Comments on the Applicant's Response to my Deadline 8 Submission - by Dr David Moore.

Dr David Moore MA (Cantab) PhD CEng FIMechE
Unique Reference Number: 20040614

Part 2 of 3 - Investigation

Figure 6. Sectional View through NMP4 and Billington Lakes showing Daytime Rail Noise $L_{Aeq16hr}$ versus Distance from Nearside Rail

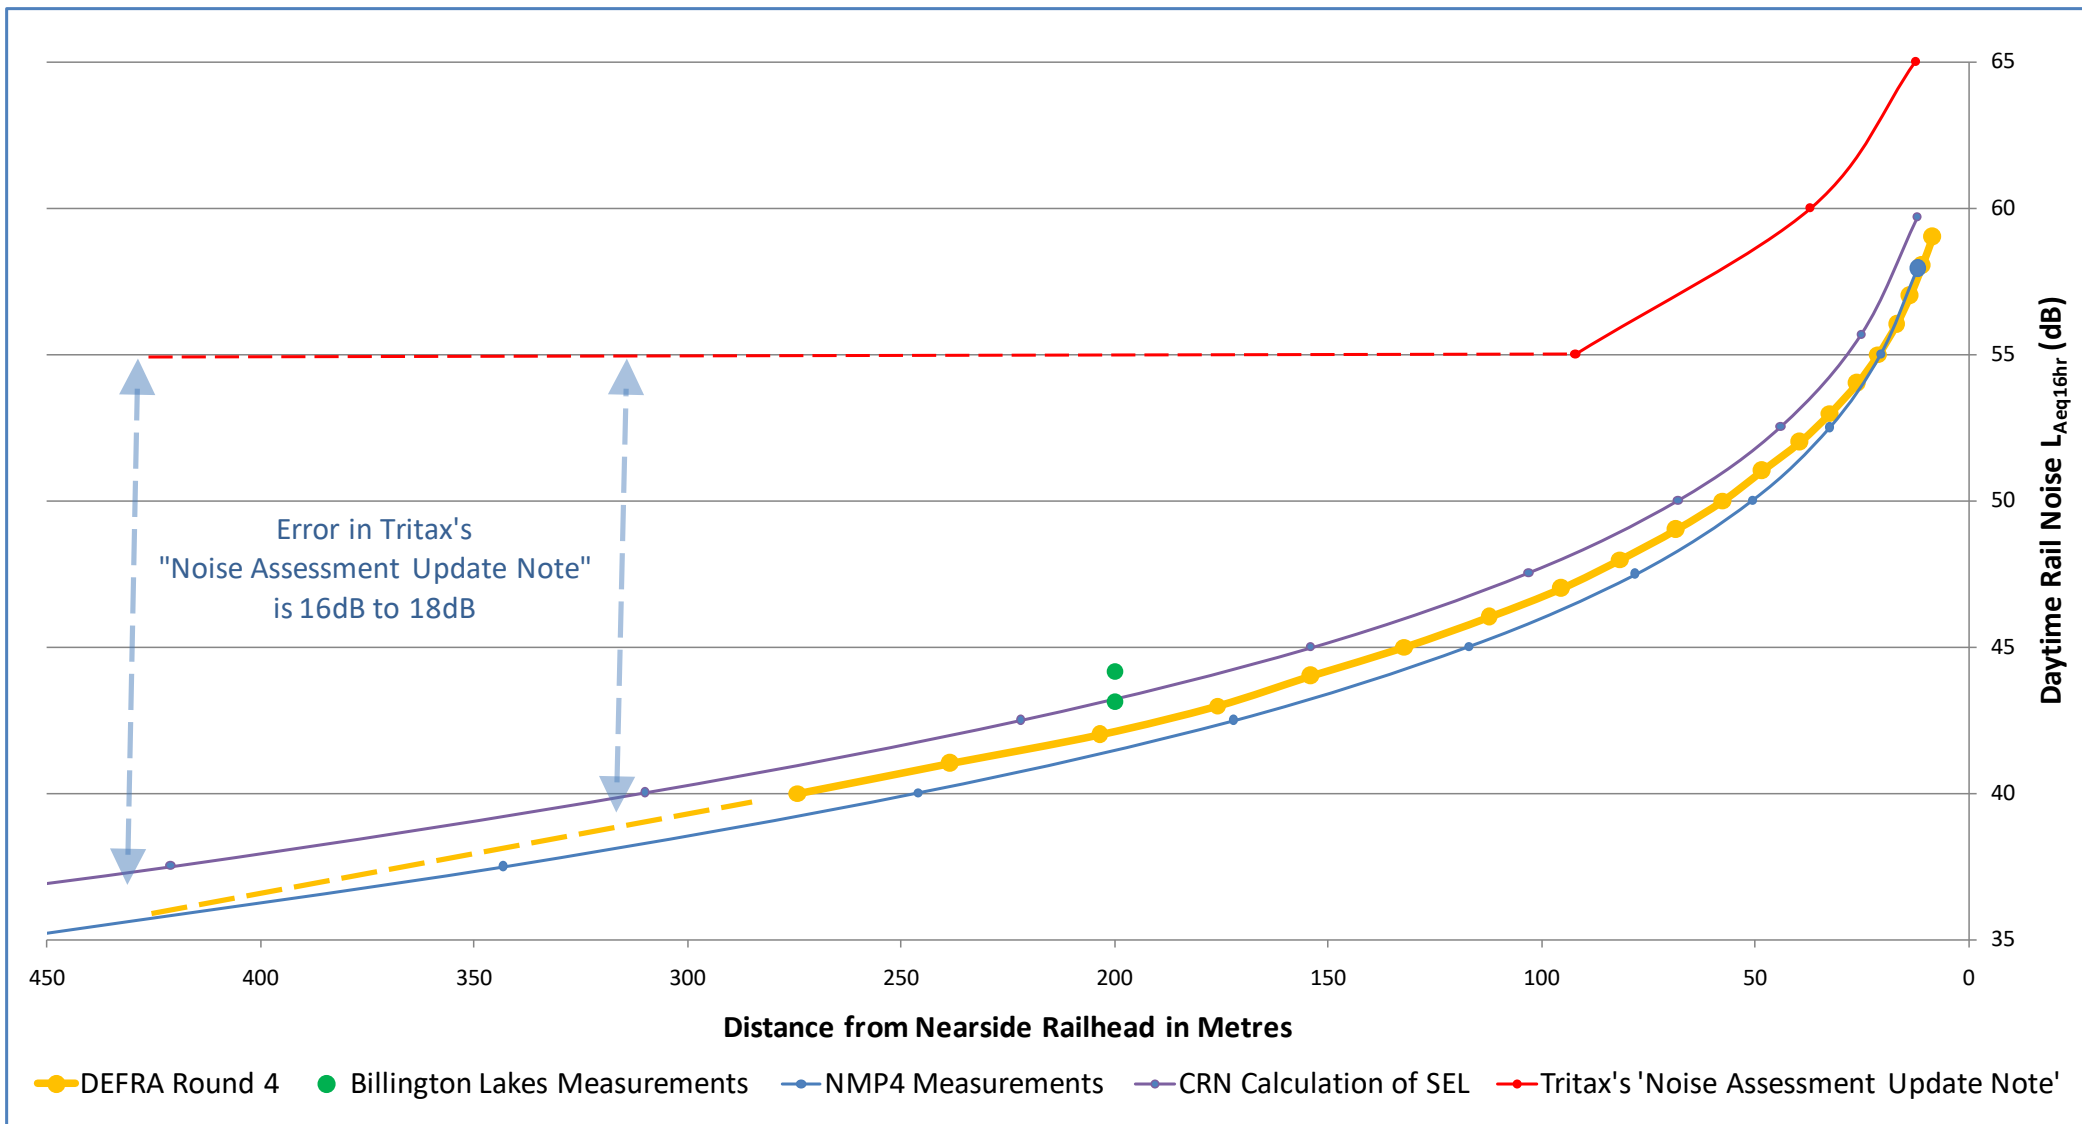
It is therefore possible to create a Sectional View of the DEFRA Round 4 Rail Noise Contours, which shows the manner in which the Rail Noise level is attenuated with increasing distance from the track. In Figure 6 I show a typical Sectional View describing the DEFRA Round 4 Rail Noise Contours at the locations of Billington Lakes and NMP4. With reference to the Key, this is shown in Gold.

Accordingly, I have included in the Sectional View the Daytime Rail Noise level measured at Billington Lakes on the 16th and 17th February 2024. This is indicated by the (upper) Green Dot, and is of course shown at a location 200 metres from the trackside. It can be seen that this (upper) Green Dot stands a little (approximately 2dB) higher than the DEFRA Round 4 Rail Noise Contour. On checking the Real Time Trains data for that 16-hour Daytime measurement period on the 16th and 17th February 2024 (data which I included in my Deadline 8 submission), it is seen there were some 16 Freight Train movements, whereas during a typical Daytime period there would be only 11. To correct for this, the upper Green dot has been replaced by the lower Green Dot, which is 1.0dB lower and agrees very closely with the DEFRA Round 4 Rail contour.

In a similar way, I have also included in the Sectional View the Daytime Rail Noise level that Tritax measured at NMP4. This is indicated by the (large) Blue Dot and is of course shown at a location 12 metres from the trackside. [This Daytime Rail Noise Level at NMP4 has been calculated by logarithmic averaging of Tritax's own Daytime Weekday and Daytime Weekend Noise Levels at NMP4, with due account being taken of the Residual Noise level at NMP4].

With reference to the Key, the NMP4 characteristic Noise Contour calculated using CRN is shown as the smaller Blue Dots and the Blue Line. Note in particular the very close agreement between this Blue NMP4 Rail Noise Contour and the Gold DEFRA Round 4 Rail Noise Contour.

In Figure 6, I therefore also show the characteristic variation of Rail Noise with distance from the trackside, calculated in accordance with the “Calculation of Railway Noise” and employing the SEL method as described above.

For completeness, I have also included in Figure 6 the characteristic Noise Contours that Tritax indicated in their “Noise Assessment Update Note”. With reference to the Key, this is indicated by the Red Dots and the Red Line. Clearly, this is very much higher than all of the others.

Figure 7. Sectional View through NMP4 and Billington Lakes showing Night Time Rail Noise L_{night} versus Distance from Nearside Rail

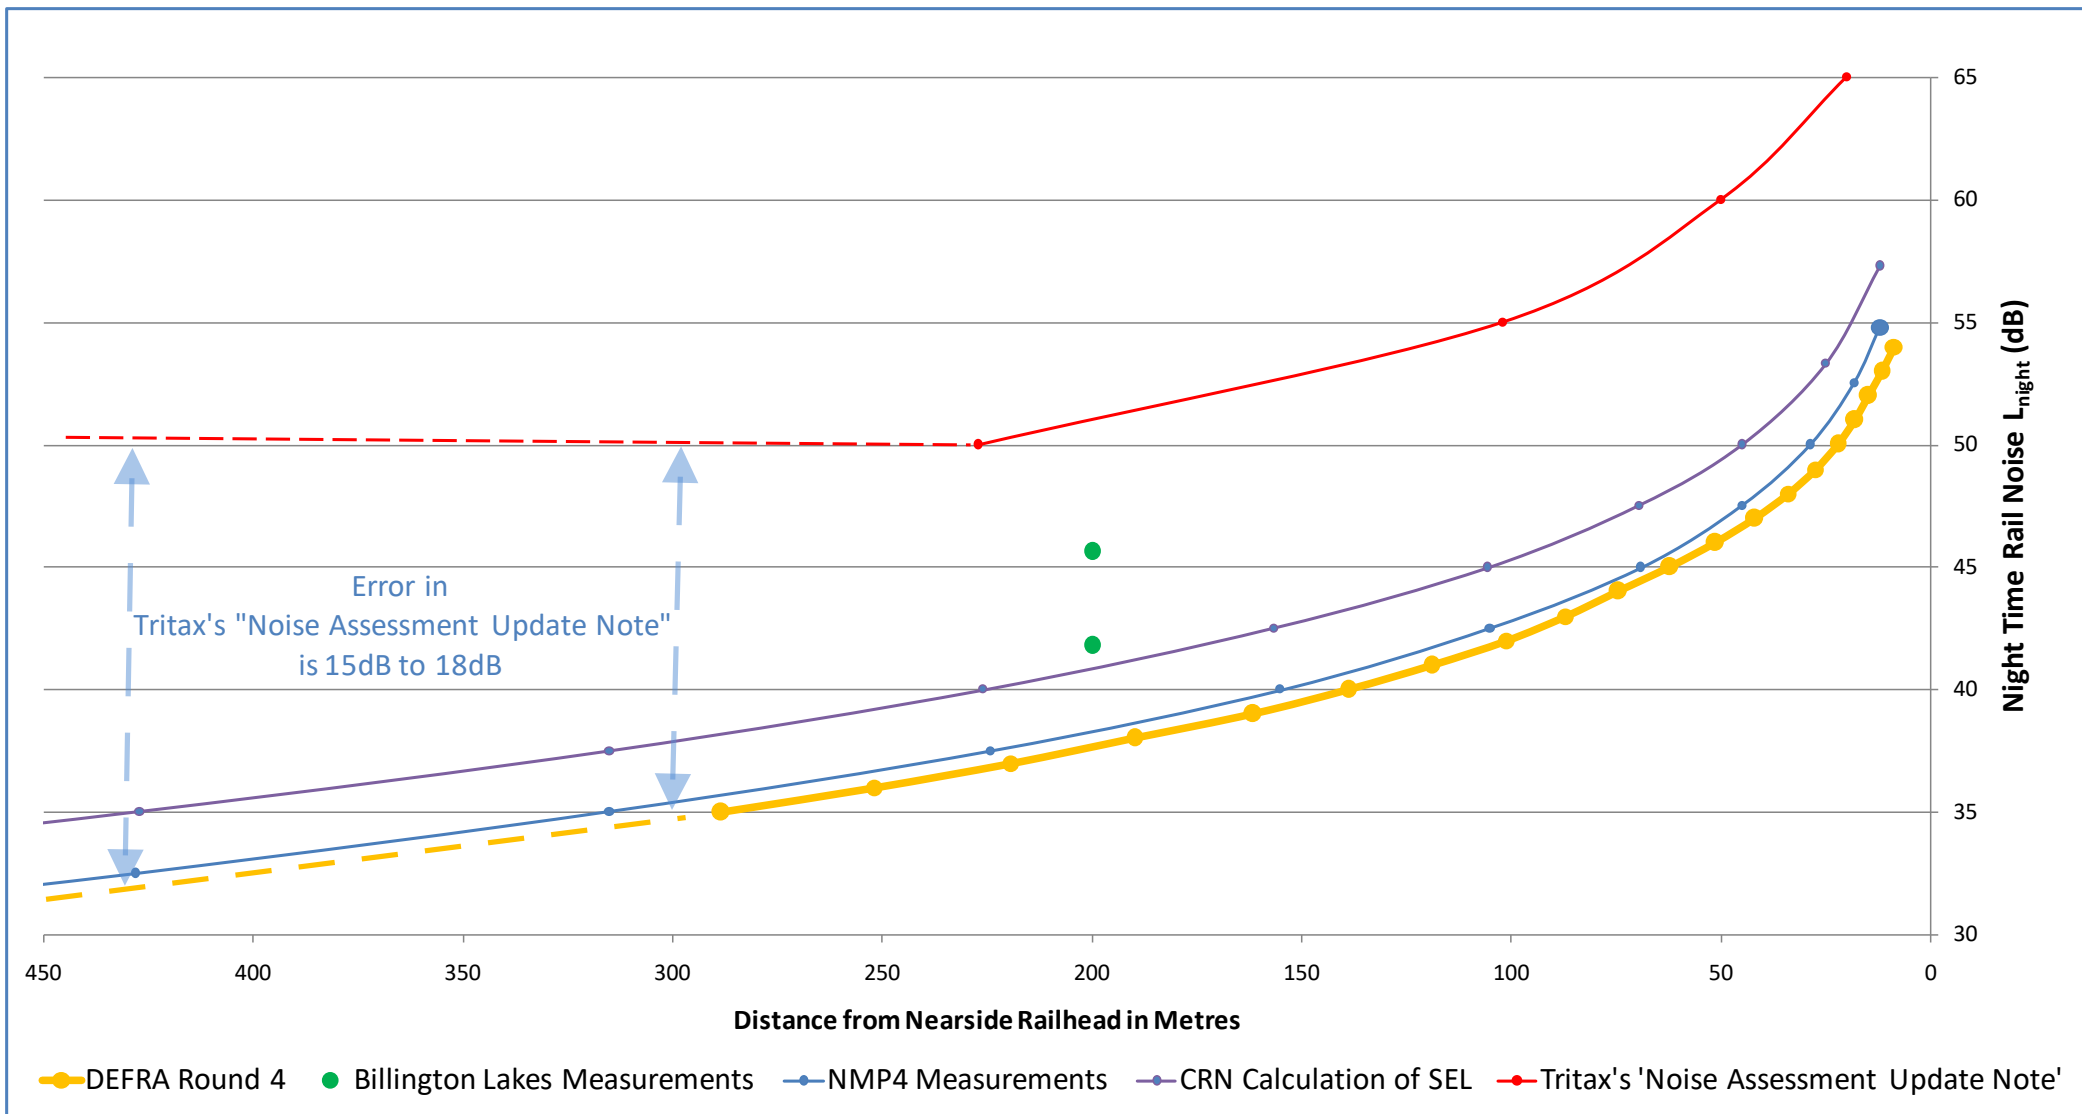
In Figure 7 I therefore show a second Sectional View in which all of the Daytime Rail Parameters I described above in respect of Figure 6 have been replaced by their Night Time equivalents. All of the colour codings remain the same.

As was the case for the Daytime Rail Noise, you will see that the Night Time Rail Noise measured at Billington Lakes on the 16th and 17th February 2024 and indicated by the (upper) Green Dot stands a little higher than the DEFRA Round 4 Rail Noise contour. On checking the Real Time Trains data for that 8-hour Night Time measurement period over those two days, it is seen that there were some 13 Freight Train movements, whereas during a typical Night Time period there would be only 5. To correct for this, the upper Green dot has been replaced by the lower Green Dot, which is 3.8dB lower and agrees reasonably well with the DEFRA Round 4 Rail Noise Contour.

For the Weekday Night Time Rail Noise level shown in Figure 7, the corresponding the upward shift is 1.0dB. For the Weekend Night Time Rail Noise level, the Rail Noise levels are very low on Sundays and on Saturday nights, and indeed can disappear entirely.

Figure 8. Sectional View through NMP4 and Billington Lakes showing Daytime Road Noise $L_{Aeq16hr}$ versus Distance from Nearside Rail

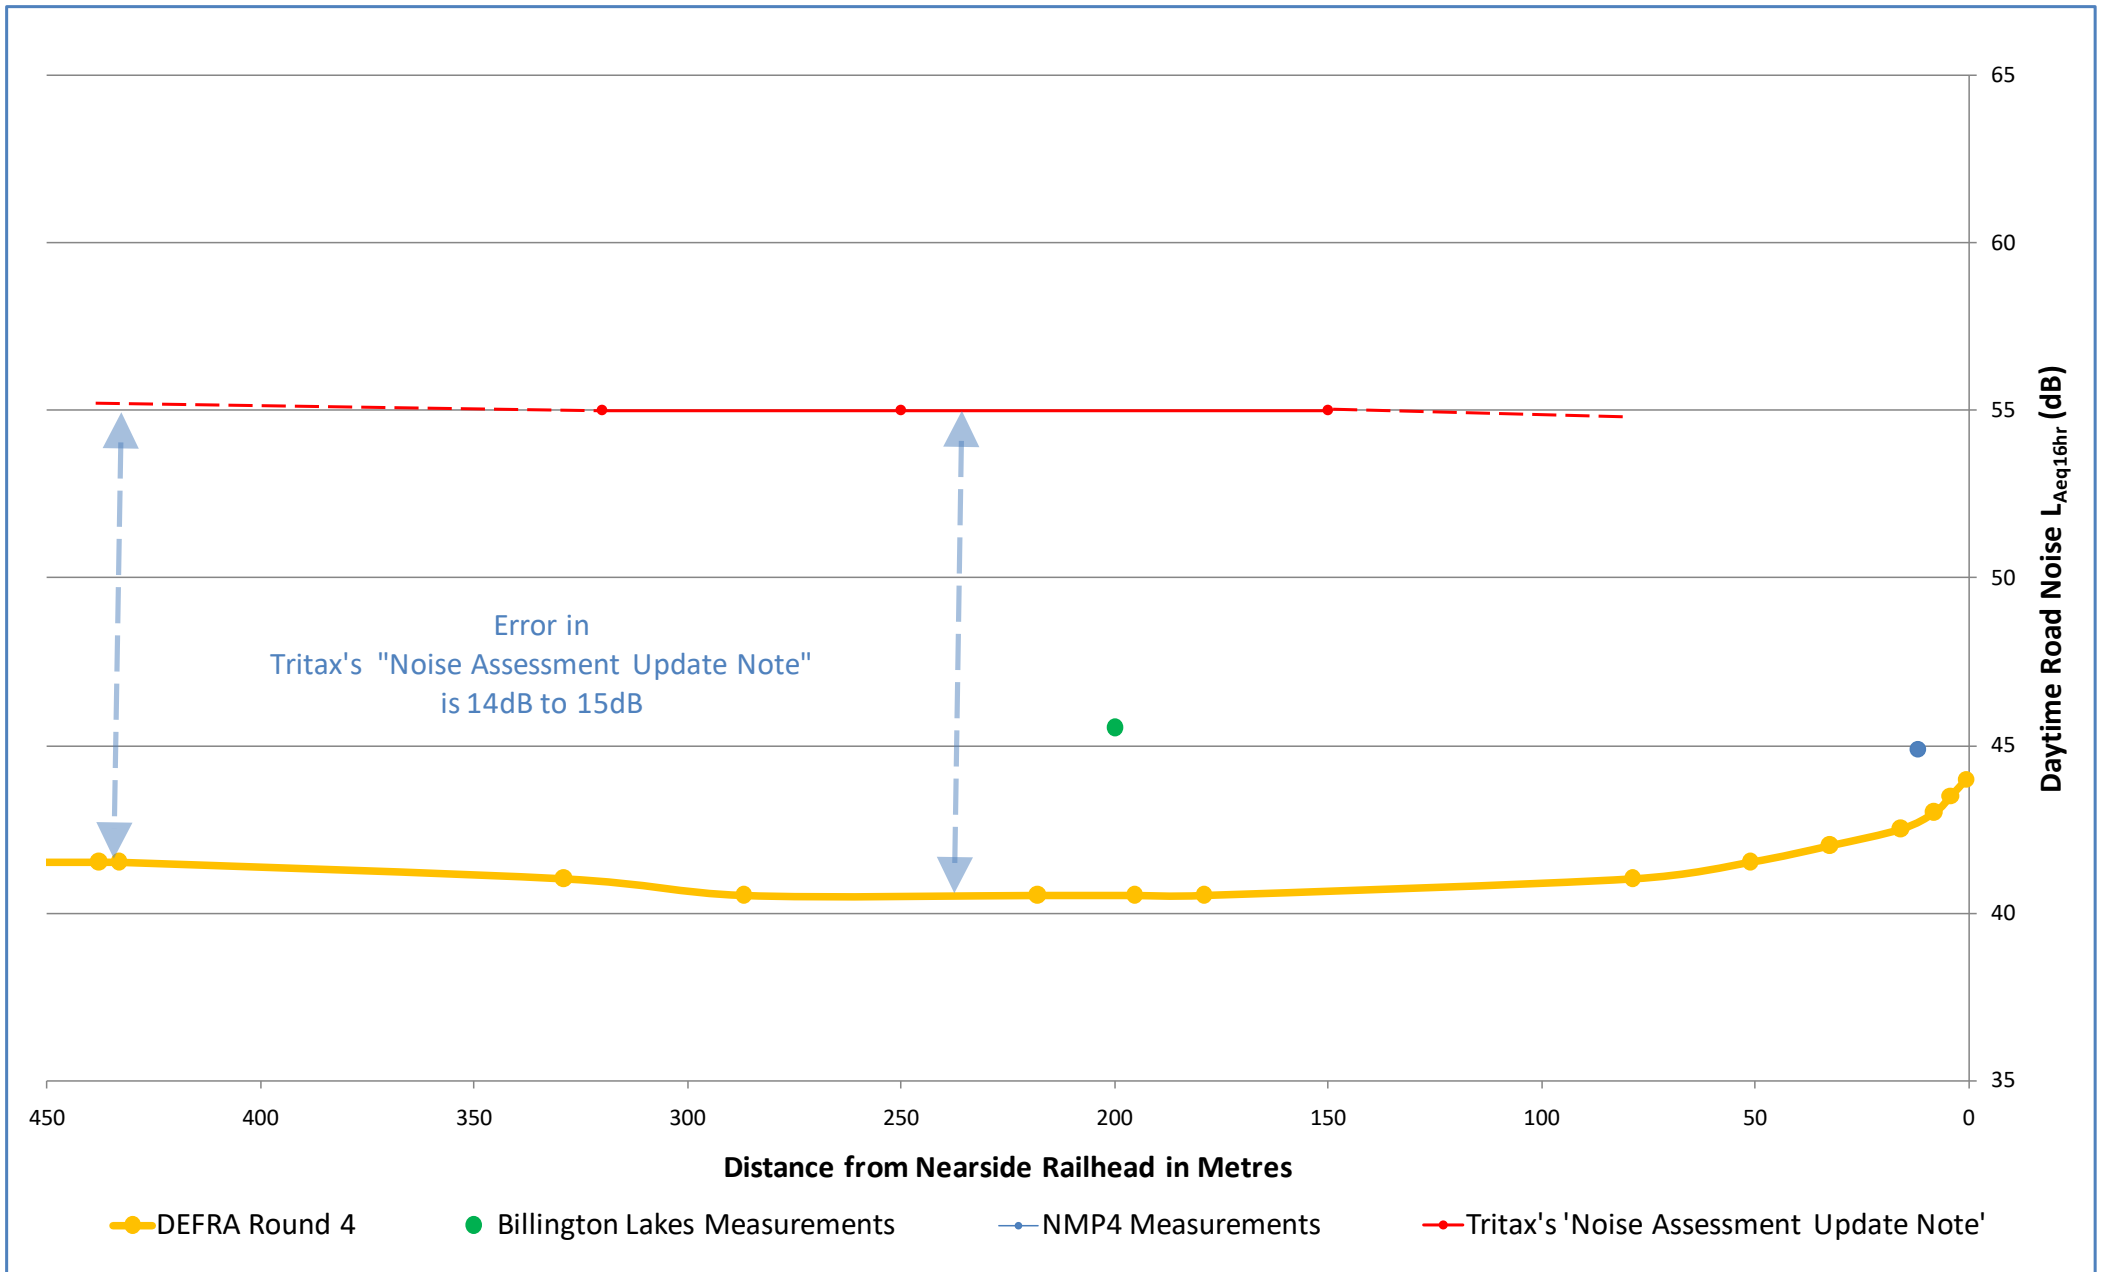
In Figure 8 I show the Sectional View in respect of **Daytime Road Noise**. This is of the same form as Figure 6 for the Daytime Rail Noise, but because the Daytime Road Noise Contour is essentially flat rather than a curved Contour, it is very much simpler. Also, of course, the SEL Rail Noise data shown in Figures 6 and 7 is not present. All of the Key colour codings remain the same.

The NMP4 Road Noise measured data is shown as a Blue Dot, at 12 metres away from the trackside where Noise Monitoring Position NMP4 was located. From my Deadline 8 Spreadsheet submission, I calculated the Daytime Road Noise level at NMP4 to be 44.9dB. This used Tritax's NMP4 Time History Graphs for the 23rd April and 24th April 2021, with reference to the Ambient Noise levels ruling in those 15-minute intervals when there were no train passes. As can be seen in Figure 8, this agrees with the DEFRA Round 4 Daytime Road Noise data very closely.

Similarly, the Billington Lakes measured data is shown as a Green Dot, at 200 metres away from the trackside where the Billington Lakes Monitoring Position was located. And as I described above, from my Deadline 8 Spreadsheet submission, I calculated the Daytime Road Noise level (actually the Daytime Residual Noise level) at Billington Lakes to be 45.5dB, using that same method. As can be seen in Figure 8, this Residual Noise level is a little (around 5dB) higher than the DEFRA Round 4 Daytime Road Noise level indicated at that location at Billington Lakes.

Indeed, local to Billington Lakes, there were waterfowl at the water's edge (noisy Mallards and Canada Geese etc.) that would have the effect of raising the Daytime Residual Noise level measured at Billington Lakes above the DEFRA Round 4 Daytime Road Noise level shown in Figure 8.

I have also included in Figure 8 the characteristic line showing the Daytime Road Noise levels that Tritax indicated in their "Noise Assessment Update Note", and indicated by the Red Dots and the Red Line. Clearly, this is again very much higher than all of the others.

Figure 9. Sectional View through NMP4 and Billington Lakes showing Night Time Road Noise L_{night} versus Distance from Nearside Rail

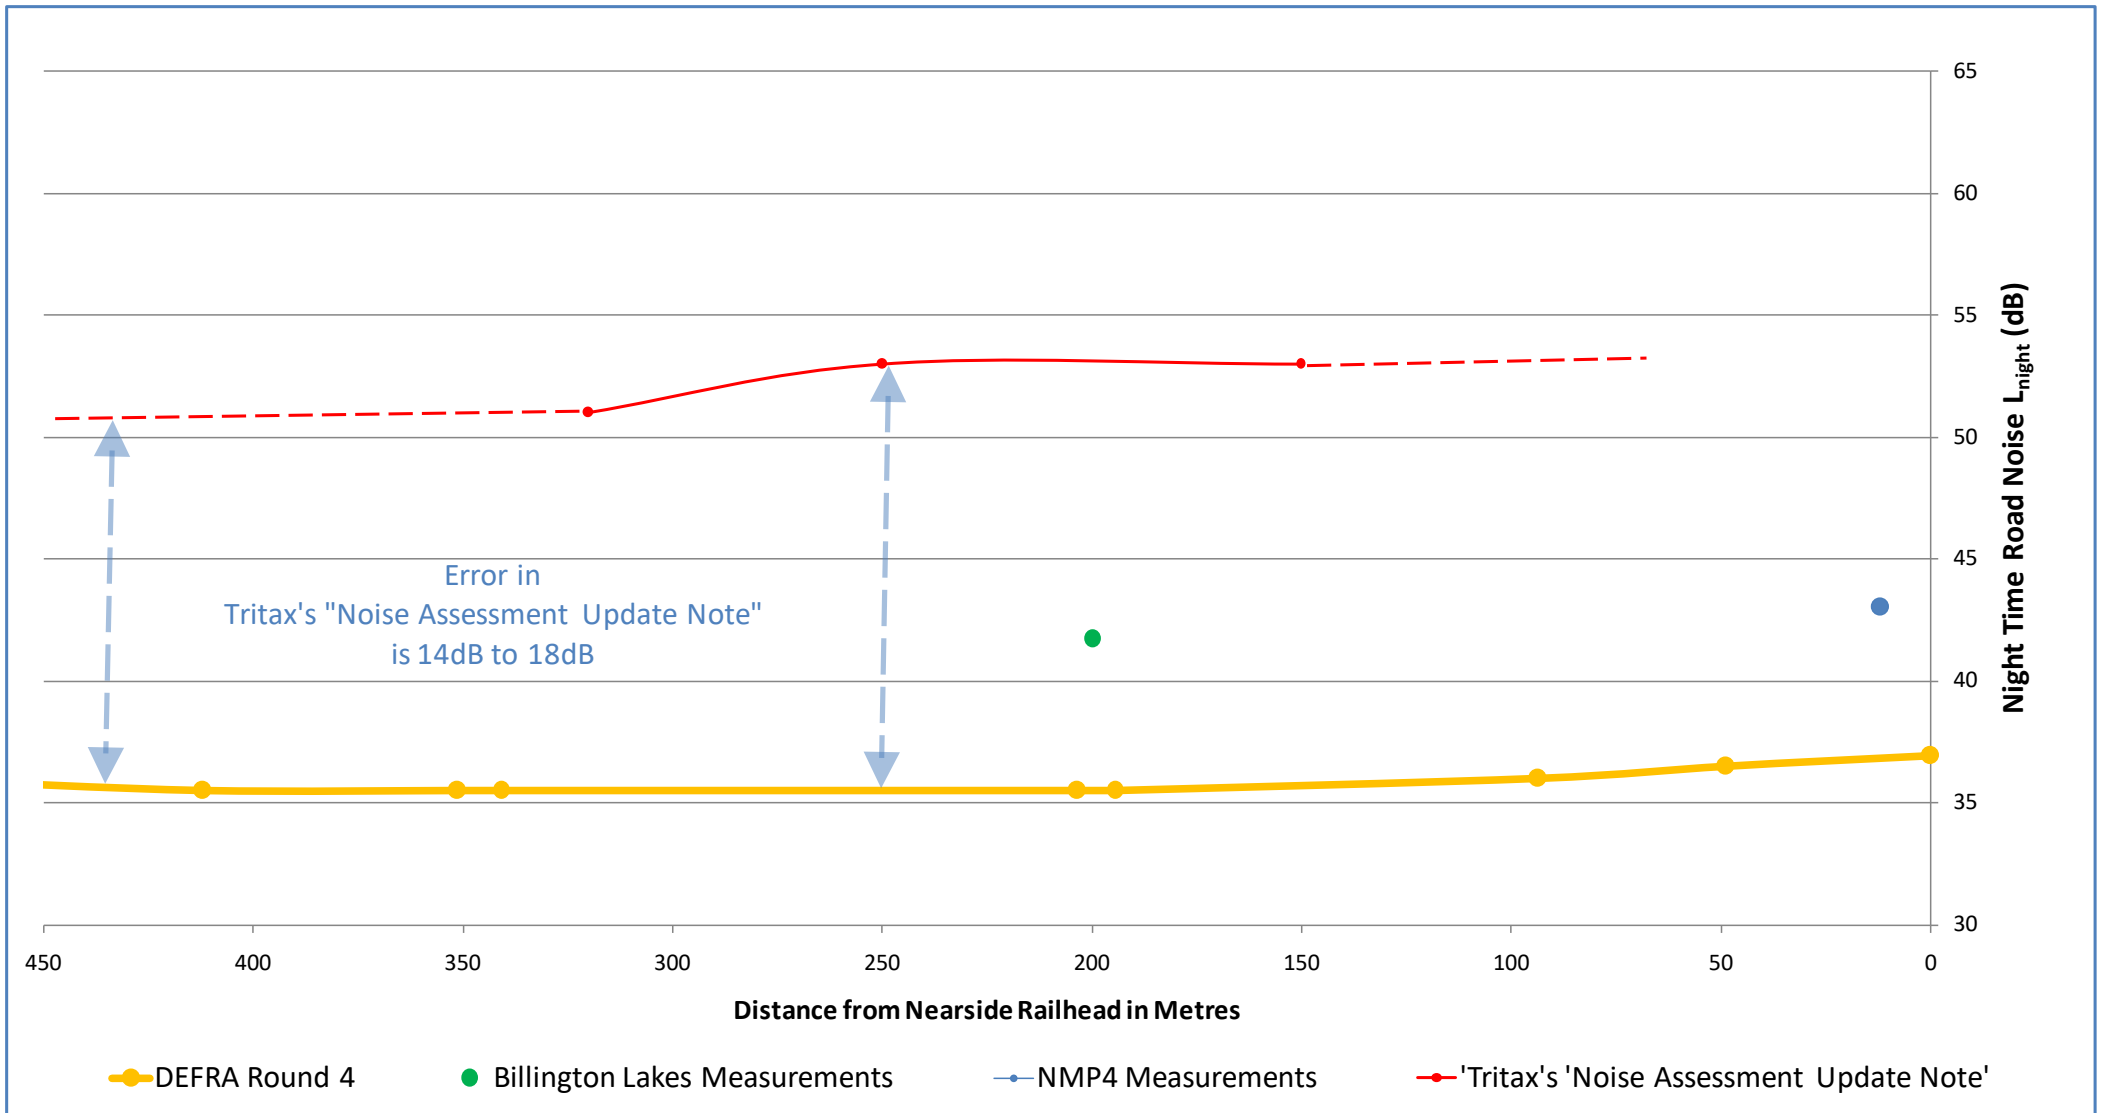
Turning now to the **Night Time Road Noise**, in Figure 9 I show a further Sectional View in which all of the Daytime Parameters I described above in respect of Figure 8 have been duly replaced by their Night Time equivalents. All of the Key colour codings again remain the same.

I have also included in Figure 9 the characteristic line showing the Night Time Road Noise levels that Tritax indicated in their "Noise Assessment Update Note", and indicated by the Red Dots and the Red Line. Clearly, this is again very much higher than all of the others.
